2010 Interim Design Standard

INTERCHANGE MARKINGS

Interim Date	Sheet No.
07/01/10	2 of 4
Index No.	
17345

2010 Interim Design Standard	Interim Date 07/01/10	Sheet No. 3 of 4
	INTERCHANGE MARKINGS	Index No. 17345

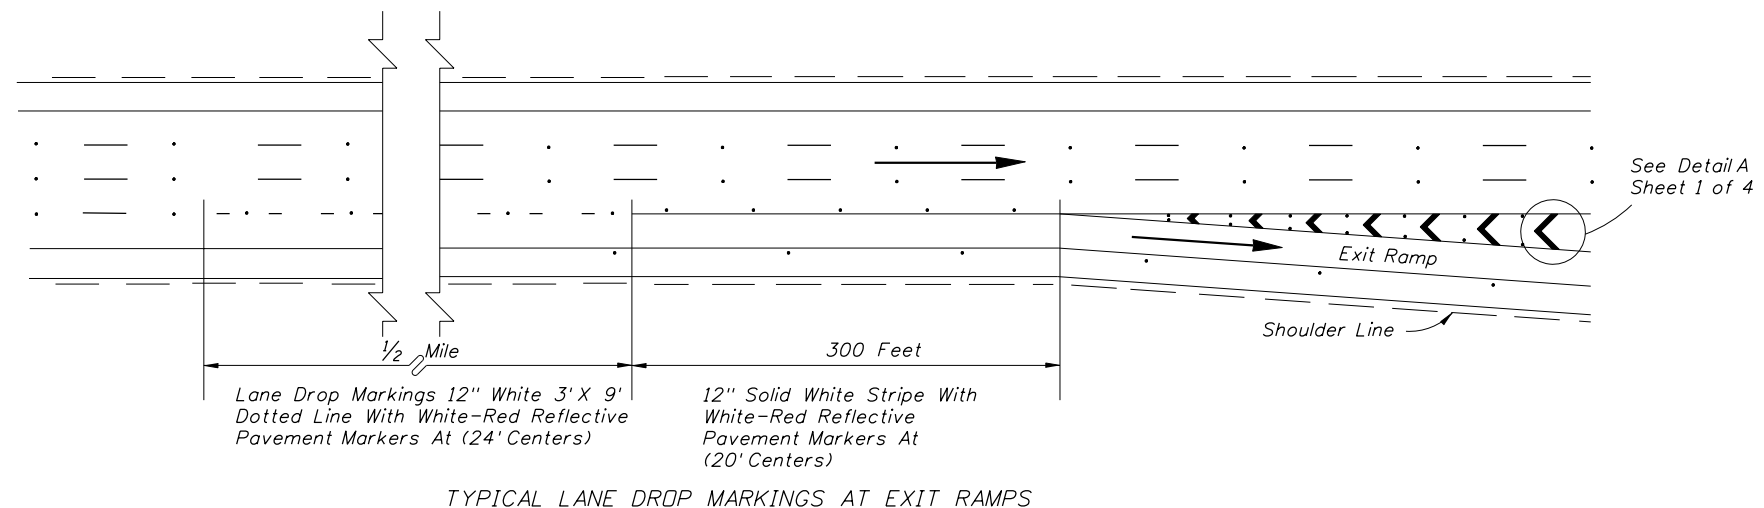
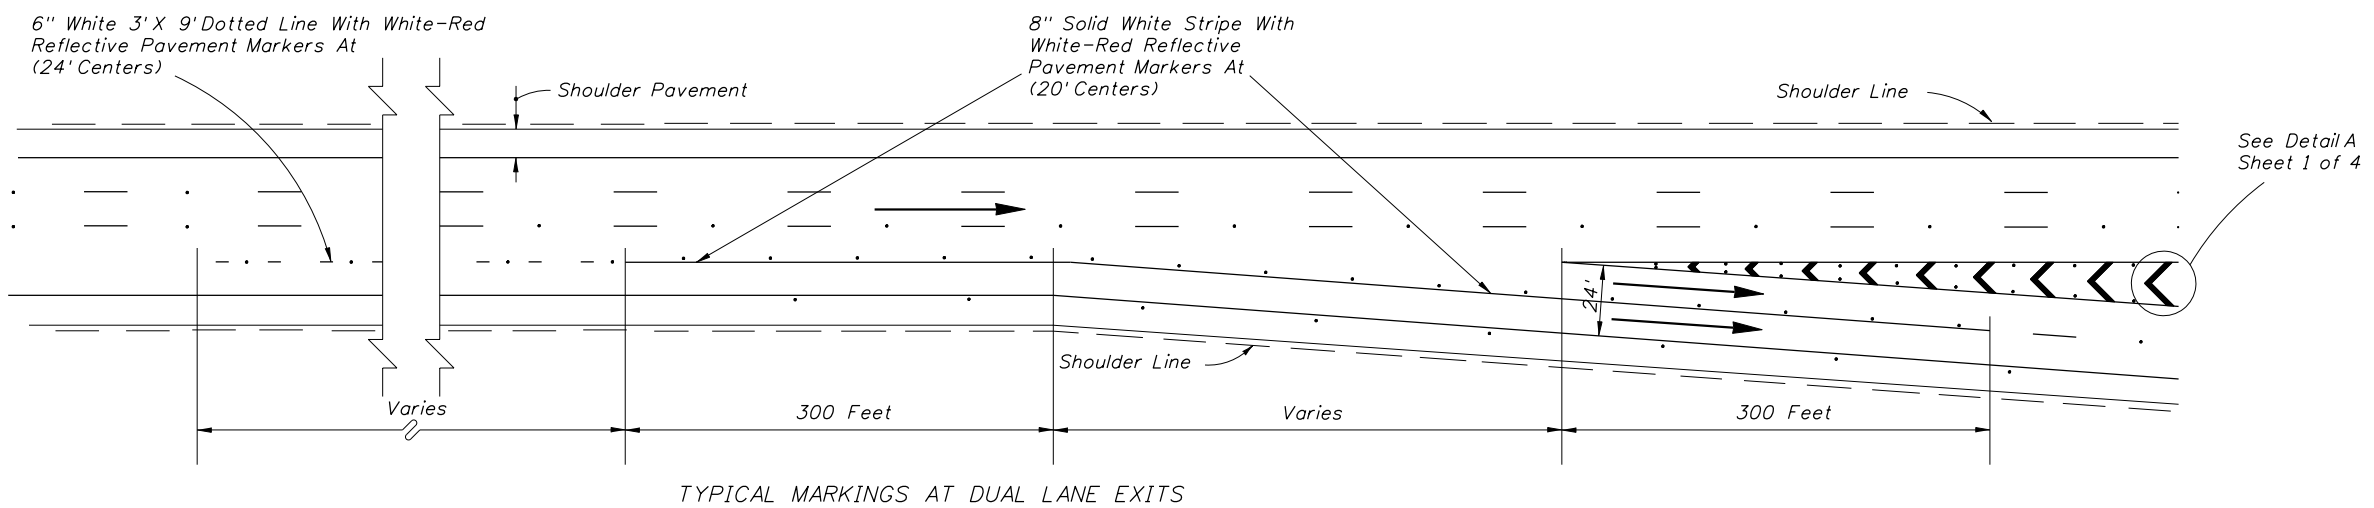
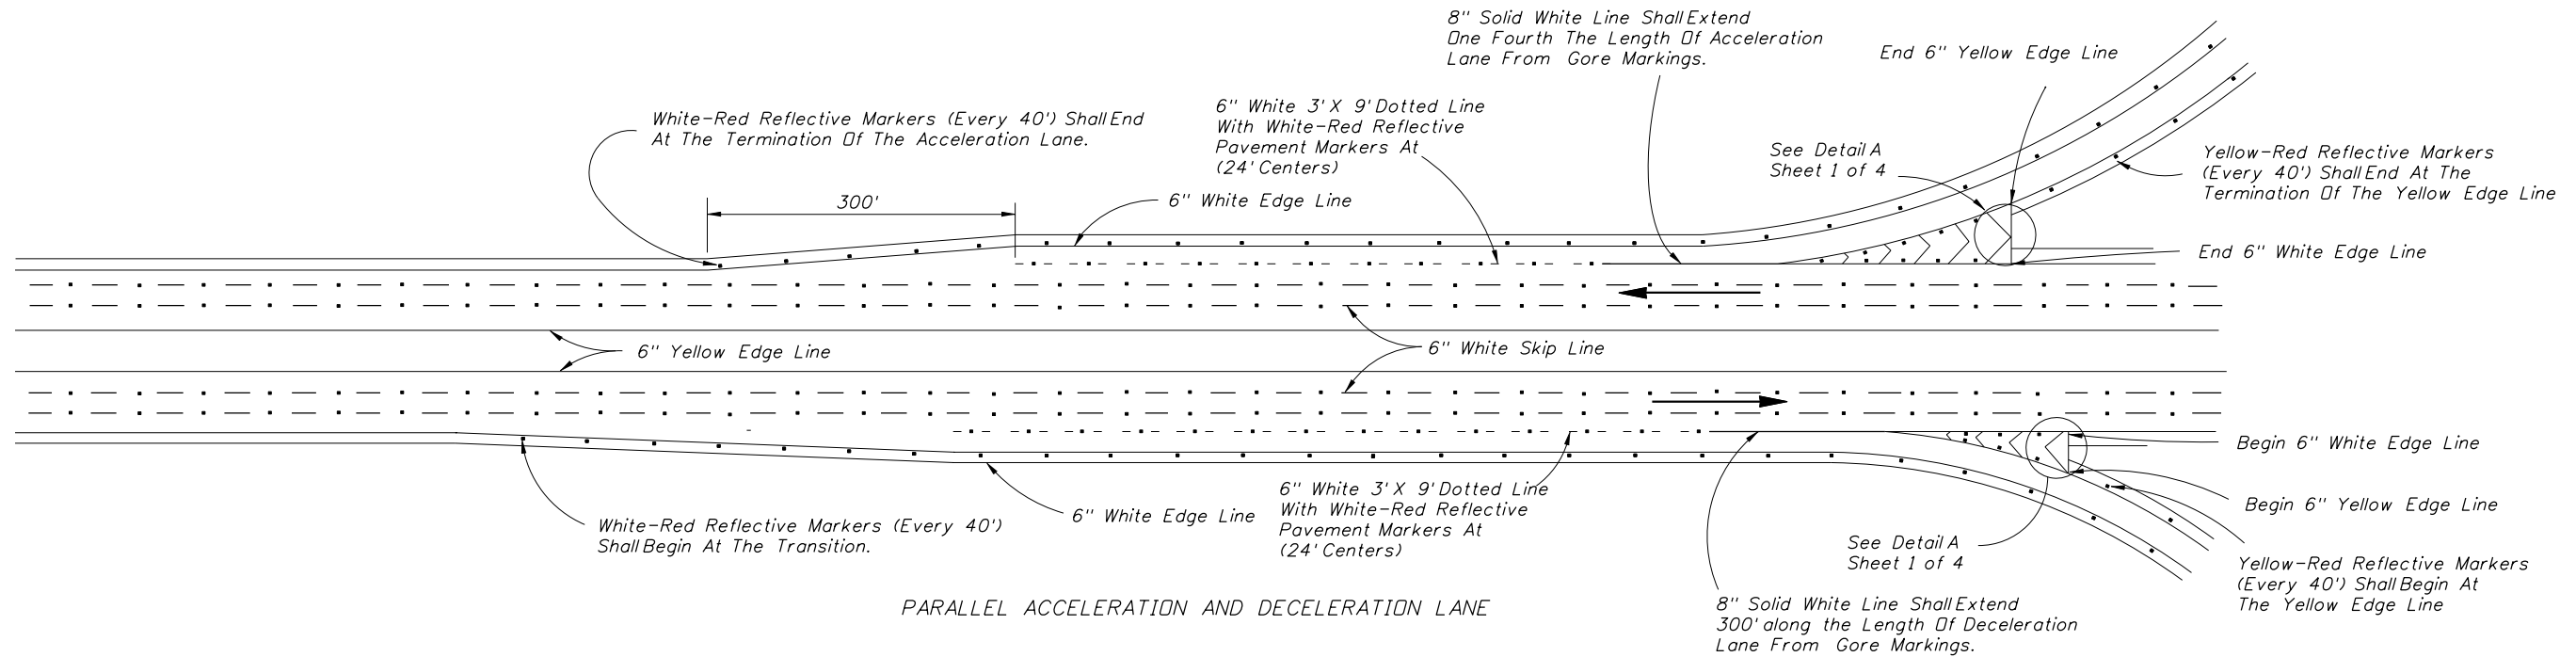
REVISIONS			
DATE	BY	DESCRIPTION	
7/16/10	C.H.	Revised Acceleration and Deceleration Lanes with 12" Solid White Lines, And 6" or 12" White 3'-9' Skip Line to Comply With The 2009 M.U.T.C.D.
